Response to the Planning Application for Installation of a Solar Park on the Ex-Landfill Site in Aldeby, Norfolk Planning

Application No: FUL/2021/0015 19th August 2021

Response to Planning Application FUL/2021/0015 Installation of a Solar Park at Aldeby Landfill Site

Prepared by Don Wiltshire, Deputy Chairman, Aldeby Waste Liaison Committee

A marked up copy of Figure 4.2 showing the location and route of the existing Haul Road is attached below.

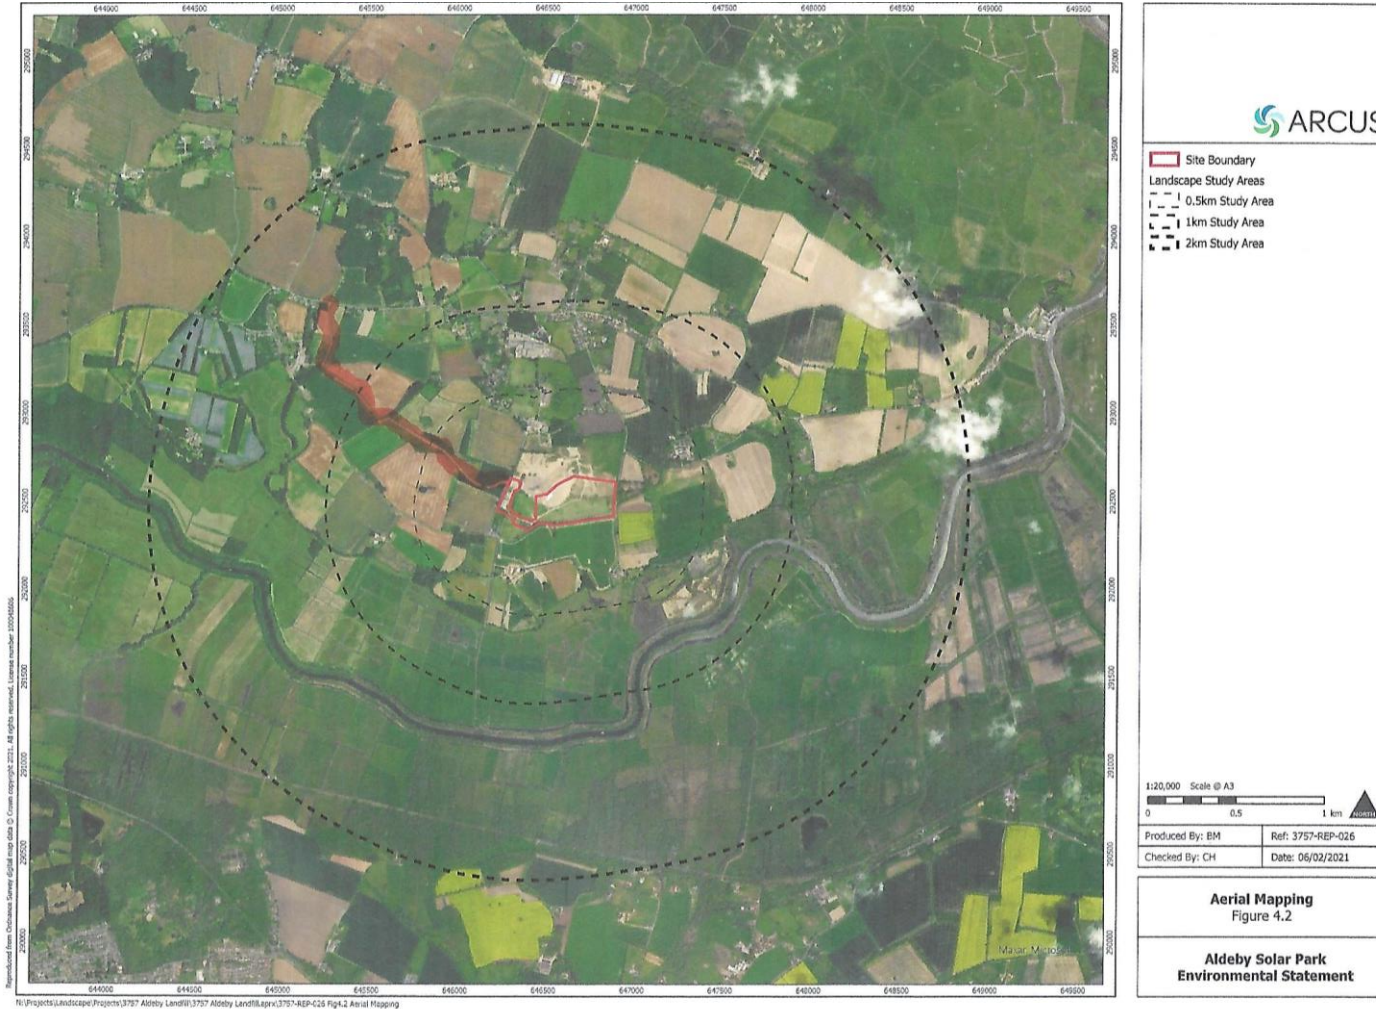
It would therefore be a safer and more acceptable solution for the Applicant to enter into an agreement with FCC Environmental and the landowners for shared use of the road over some part of this remaining period while construction of the Solar Park is ongoing.

A marked up copy of Figure 4.2 showing the location and route of the existing Haul Road is attached below.

The comments above detail additional sensitivities which demonstrate that these proposals will in fact increase risk and reduce the safety of the residents. Furthermore a route following the existing landfill access road would provide safe access with minimal traffic impact
